Subject: Wolf Creek site visit and review, April 21,  
1982 - Seismic and Geologic Considerations

Subject: Additional comments on my letter of October 1,  
1979 referring to the Wolf Creek Project

Microearthquakes (\*) And Faults (—) In Kansas

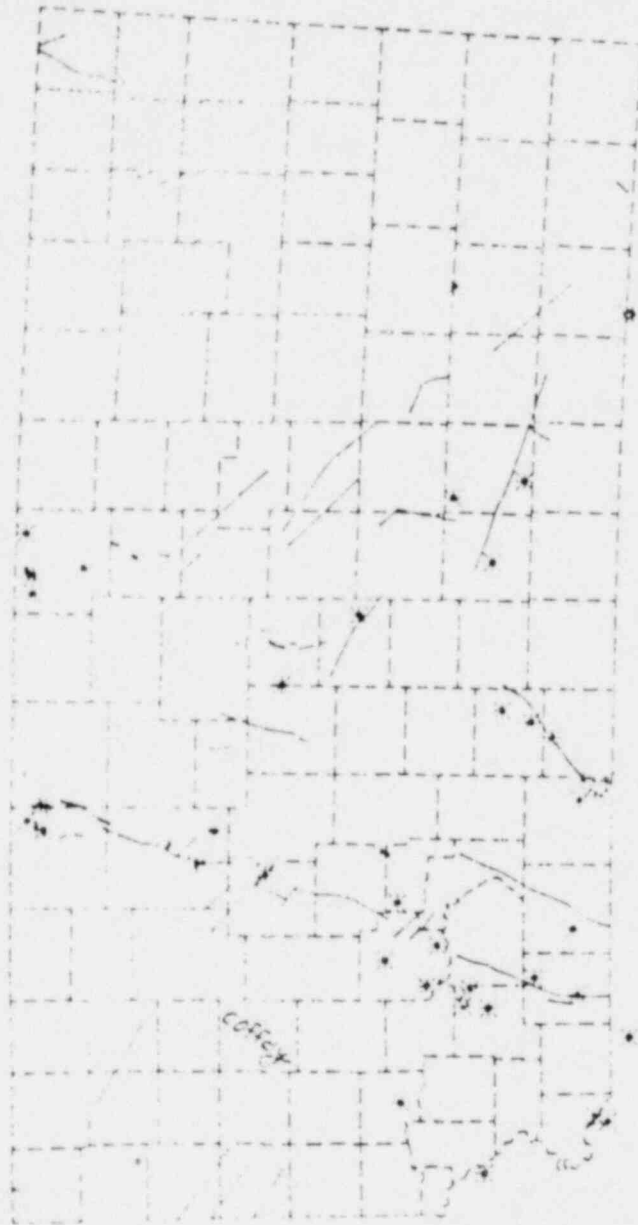
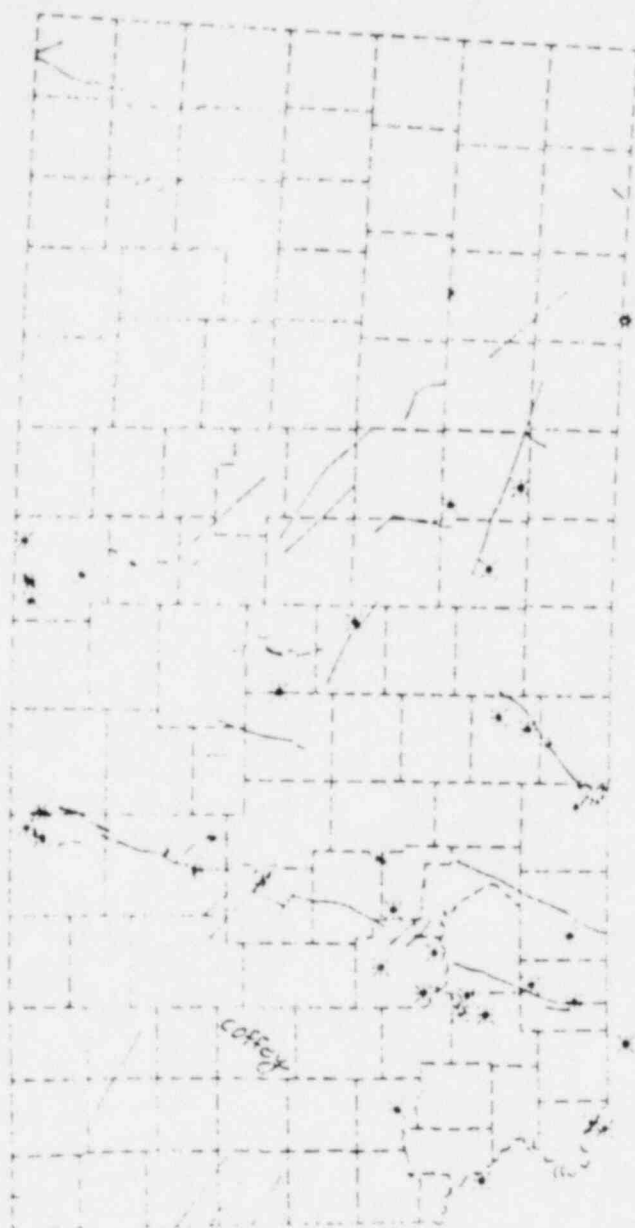
1. The seismic risk at the plant site is extremely low.
  - a. Presentation by Frank Wilson of the Kansas Geological Survey, who emphasized the absence of surface, subsurface or geophysical evidence for faulting near the plant site, and the absence of seismic activity in the 19 counties of southeastern Kansas, including Coffey County. Dr. Wilson noted that the distribution of microearthquakes observed on the state network closely approximates historical earthquakes, and that neither has been recorded from southeastern Kansas.
  - b. Note also that the controlling earthquakes, the 1867 listed as intensity VIII, and the 1906, intensity VII, together with 8 other felt earthquakes (10 of 25 total in the state) are arranged in an east-west belt in northeastern Kansas, and that a concentration of microearthquakes

occurs in the same area. This reinforces the opinion expressed in my letter of 11/26/79 to Mr. Harold Etherington that the controlling faults trend easterly rather than north-south, the trend of ancient bounding faults of the Nemaha uplift. The current regional maximum compressive stress is oriented east-west (Zoback and Zoback, Jour. Geophys. Research, Nov. 1980, p. 6148), hence, reactivation of easterly trending normal faults would be predicted. There is no indication that such faults exist in the Coffey County region.

Fig. 3

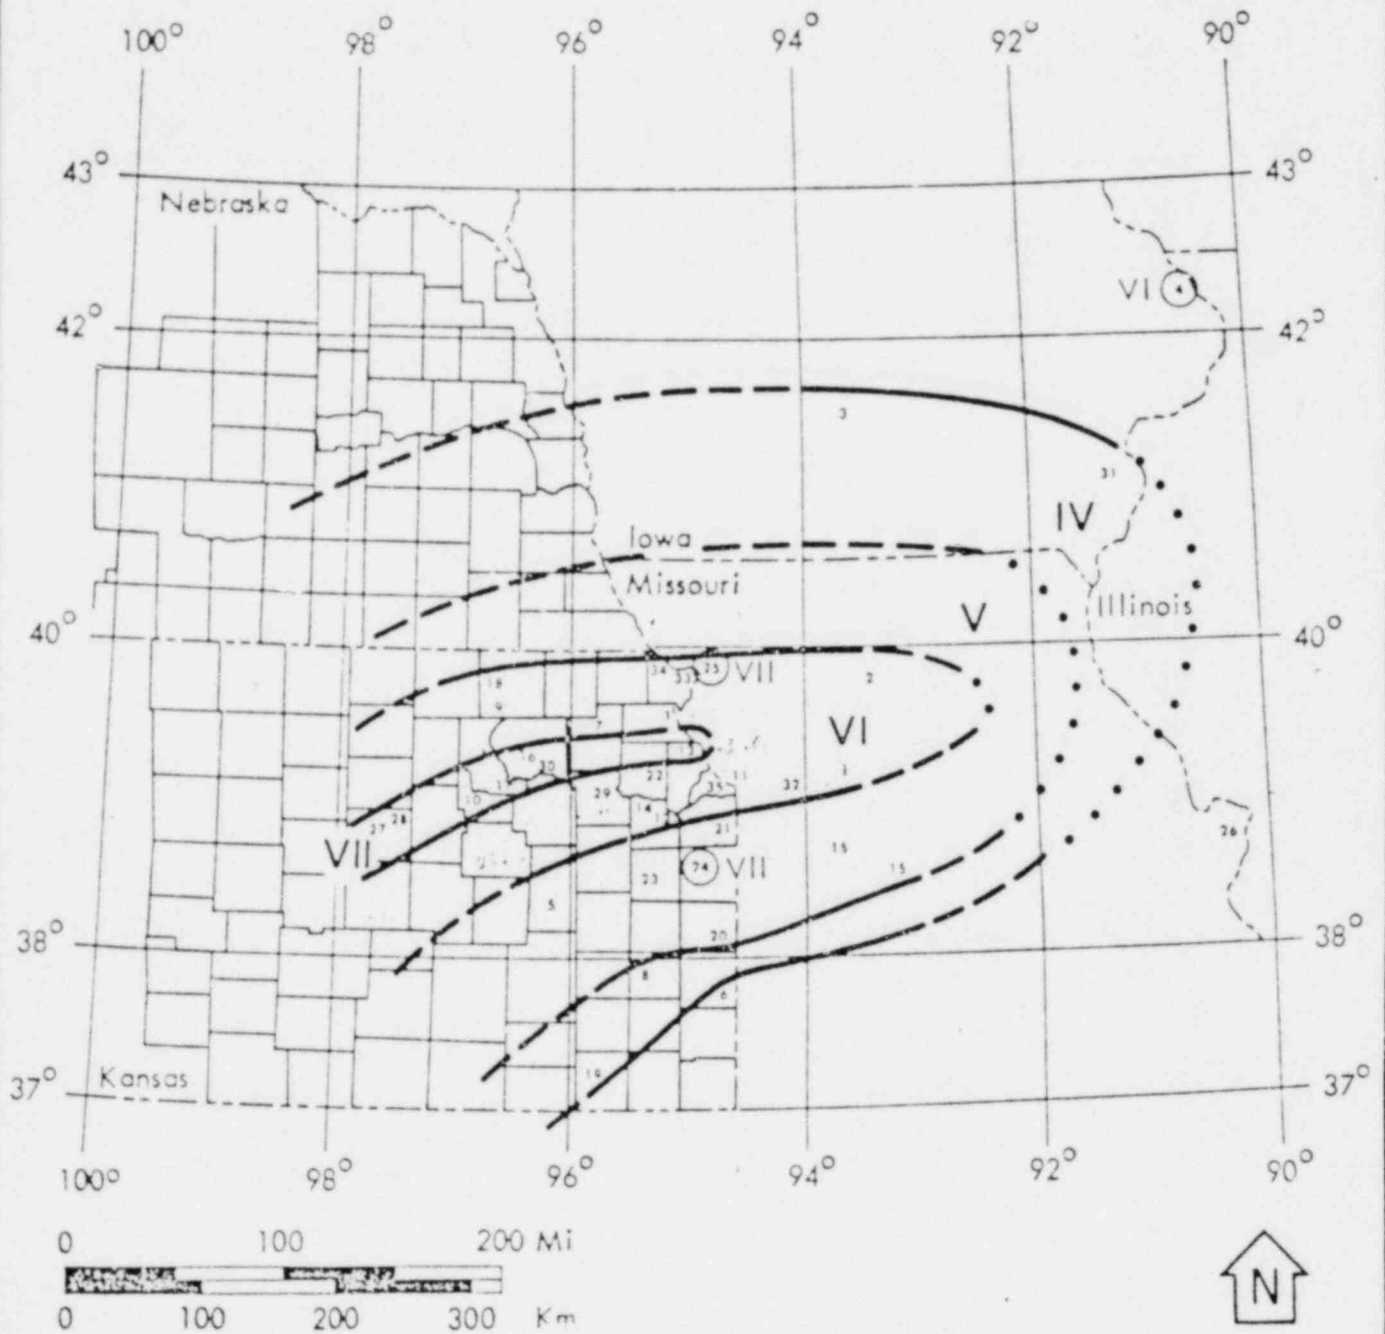
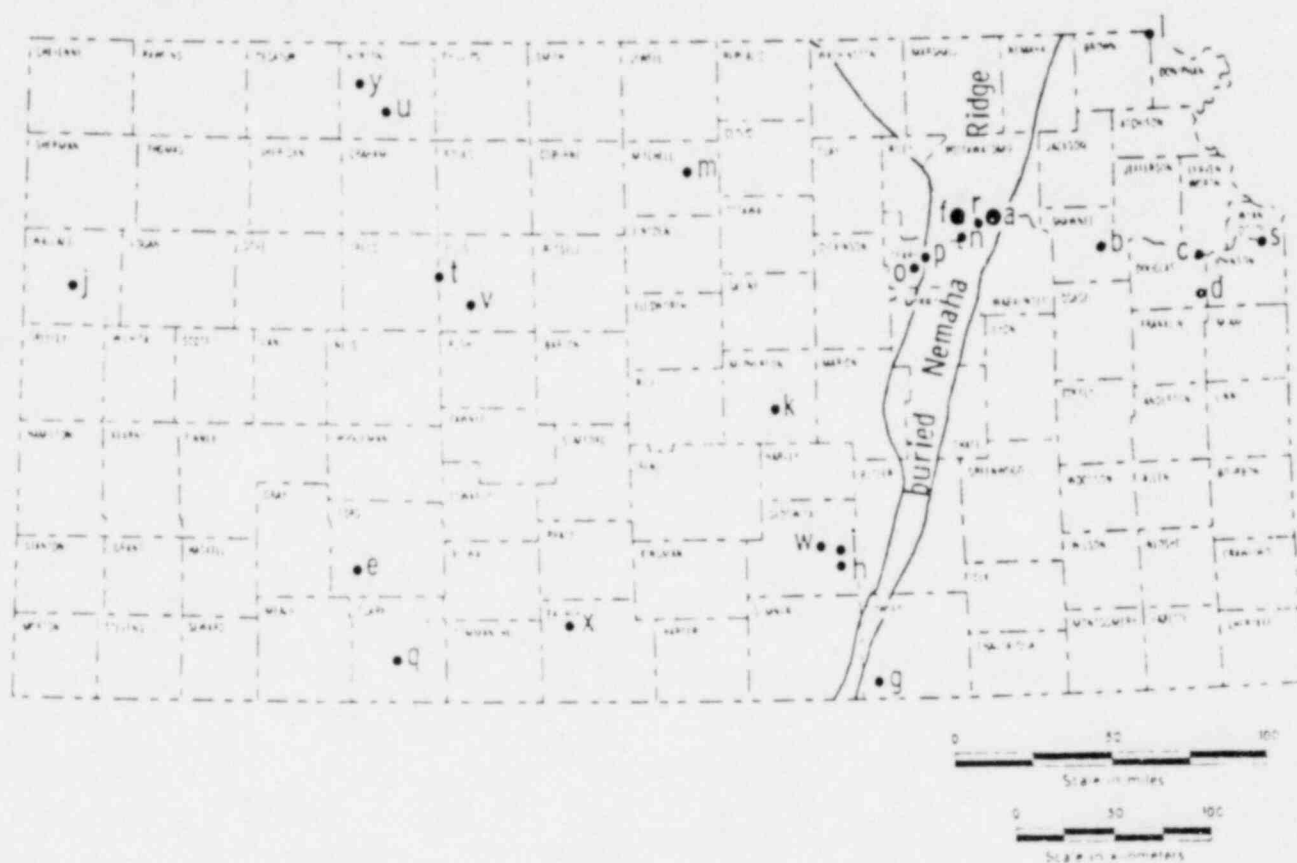
The isoseismal lines shown in figure 3 are reasonably well established for the eastern half of the figure, but the shape and extent of the western half is unknown. Note also the highly elongated intensity VII zone, which could extend westward or southwestward for an unknown distance. From reading the accompanying damage reports, it seems to me that the choice of a location for the epicenter within this 150-mile long zone of intensity VII is quite arbitrary. For example, at the western end of the zone, location 28, it was noted that: "train on Pacific Railroad violently rocked by shock, locomotive was stopped and train men abandoned cab for fear the boiler was about to blow up," and to the east, at location 13, Leavenworth, Kansas, "man shaken off load of hay; two contiguous buildings lifted up, separated two inches, settled back; nearly everything toppled over in private homes; several chimneys overthrown." At the site chosen for the epicenter near Wamego (number 30 on figure 3) the damage to buildings appeared to

be comparable to that observed throughout this long zone. The apparent reason for locating the epicenter here, other than its nearness to the trace of the Humboldt fault, was an observation that "on the farm of John Cotton . . . during the earthquake the earth opened and water was thrown out of the opening in considerable quantities. At another place not far distant from the above, the earth opened and fire and smoke issued out. So one of our papers states". To this phenomenon the writers assign a questioned intensity VIII. If this were a bonafide major occurrence of sand boils in unconsolidated sediments, then an assignment of intensity VIII would probably be justified. However, in view of the very similar degree of damage throughout the isoseismal VII zone, and the lack of evidence of greater damage in the Wamego area it would seem to me more probable that the observed phenomena were related to escape of marsh gas and accompanying water. I see no compelling reason for raising the intensity in this area to VIII.
